Safety Recall – Toyota All Weather Floor Mat Accessory for 2007 and Early 2008 Model Year Camry

Toyota Camry All Weather Floor Mat Involved in this recall

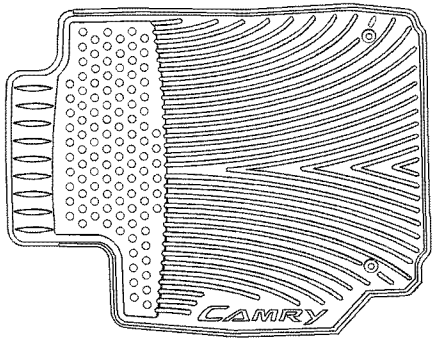
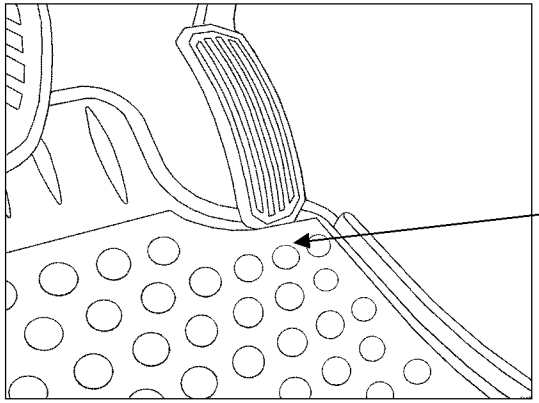
If the Toyota Camry All Weather Floor Mat is not **secured by the retaining hooks (clips)** and the mat moves forward, it may interfere with the accelerator pedal.

- In recent months, Toyota has received reports regarding the optional Toyota Camry All Weather Floor Mat (floor mat constructed from heavy duty rubber) slipping forward and interfering with the movement of the accelerator pedal. Toyota has investigated these reports and determined that if the optional Toyota Camry All Weather Floor Mat (either by itself or if it is placed on top of an existing carpeted floor mat) is **not secured by the retaining hooks (clips)** and the mat moves forward, it may interfere with the accelerator pedal from returning to the idle position.

- A newly designed replacement driver's seating position All Weather Floor Mat will be available in two to three months. Until the replacement floor mat is ready, a preliminary owner notification letter will sent to vehicle owners requesting their assistance in regularly verifying the floor mat is properly secured using the retaining hooks (clips) provided. If the mat is properly secured, it will not interfere with the accelerator pedal.
- A second owner notification will be sent when the replacement floor mat is available. The original driver's seating position All Weather Floor Mat will be exchanged for the new one at that time.
- Possible Mailing Schedule
  - Area September 26, 2007
  - Dealer September 27, 2007
  - Owner October 4, 2007
